APPLICATION NO.	FILING DATE	FIRST NAMED INVENTOR	ATTORNEY DOCKET NO.	CONFIRMATION NO.
10/661,585	09/15/2003	Dimitar Danev	028987.52515US	8044

Office Action Summary

DETAILED ACTION

Attachment: one marked-up page of Switzerland Patent, CH-444,414

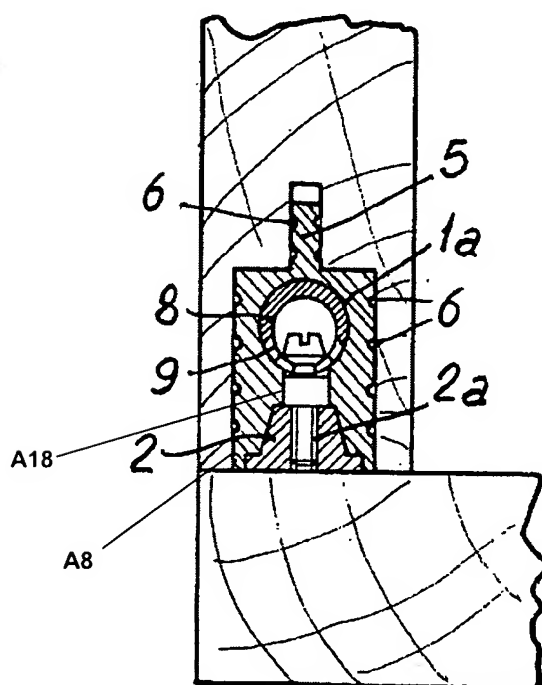
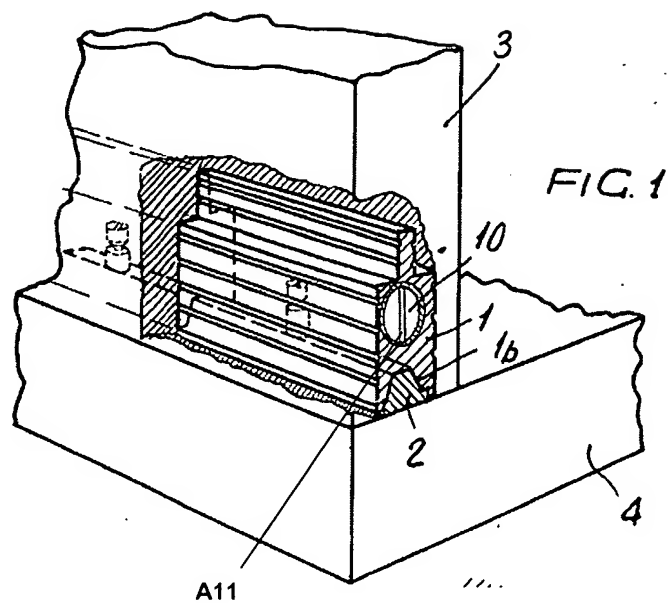
Claims 1, 2, 21, 22, 31, and 33-36 are rejected under 35 U.S.C. 102(b) as being anticipated by Switzerland patent, CH-444414 (see marked-up attachment).

Regarding claim 1, the Switzerland patent, discloses, in Figures 1-5, a releasable connection between two adjoining body shell part components, comprising a first component **4** and a second component **3**. The releasable connection comprises the first component **4**, the second component **3**, at least one base plate **2**, and a receiving device **1**. The base plate **2** is held in use in position on a first component **4** and has at least one projection pin **7**. The receiving device **1** is fastened to the second component **3** and has a rotatable slotted sleeve part **8**. An end-side profiled head section **7d** of the projection pin **7** is guidable through an opening **A8** of the second component **3**, an opening **A18** of the receiving device **1** and an opening **9** of the sleeve part **8**. Fastening of the first component **4** and the second component **3** with respect to one another takes place as a result of radial rotation of the sleeve part **8**.

Regarding claim 2, the releasable connection comprises at least two mutually spaced projection pins **7**, arranged on the base plate **2** or on two separate base plates.

Regarding claims 21 and 22, at least one face-side end of the sleeve part **8** is closed by a wall **10**. A narrow longitudinal slot **A11** is provided at the wall **10**.

Regarding claim 31, the sleeve part 8 has an eccentric construction.
